**Moxa Inc.**

Product Discontinuance Notification—PDN# 0000445507**July 15, 2026**

We would like to inform you that the NPort IA5000 and NPort IA5000A will reach its End of Life (EoL) phase, starting May 01, 2026.

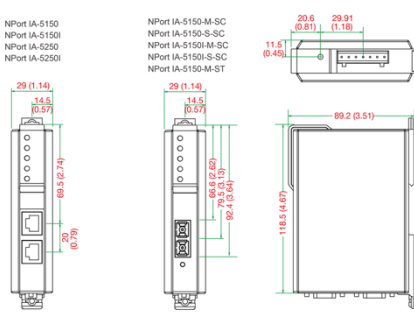
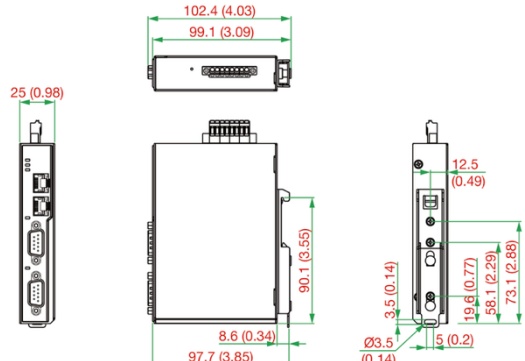
Specification	NPort IA-5150/IA-5250 (EoL)	NPort IA5150-G2/IA5250-G2 (Replacement)
Dimensions	29 x 118.5 x 89.2 mm 	25 x 129 x 89 mm

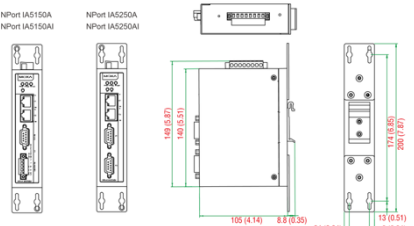
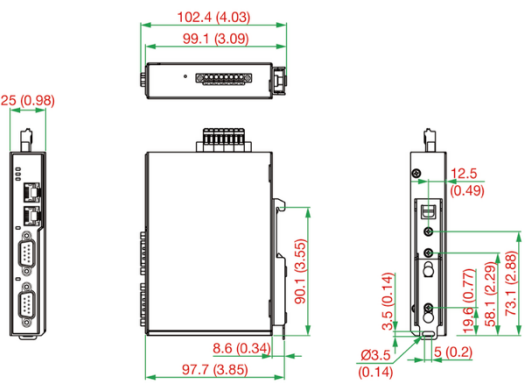
Specification	NPort IA5150A/IA5250A (EoL)	NPort IA5150-G2/IA5250-G2 (Replacement)
Dimensions	36 x 140 x 105 mm 	25 x 129 x 89 mm

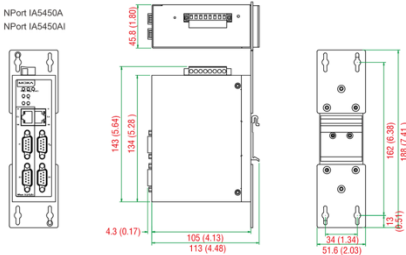
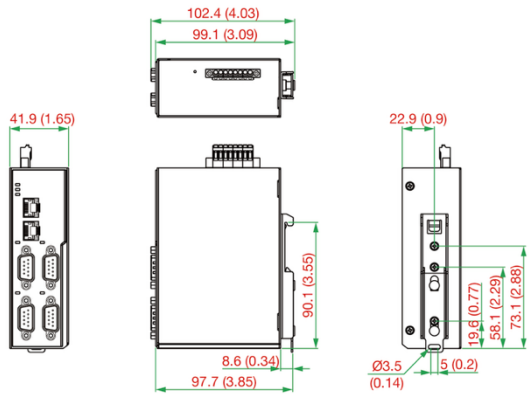
Specification	NPort IA5450A (EoL)	NPort IA5450-G2 (Replacement)
Dimensions	45.8 x 105 x 134 mm  Front view: 45.8 (1.80) x 105 (4.13) x 134 (5.28) Top view: 143 (5.64) x 105 (4.13) x 113 (4.46) Side view: 134 (5.28) x 113 (4.46) x 51.6 (2.03)	42 x 89 x 129 mm  Front view: 42 (1.65) x 89 (3.51) x 129 (5.08) Top view: 102.4 (4.03) x 99.1 (3.90) x 90.1 (3.55) Side view: 42 (1.65) x 90.1 (3.55) x 129 (5.08)
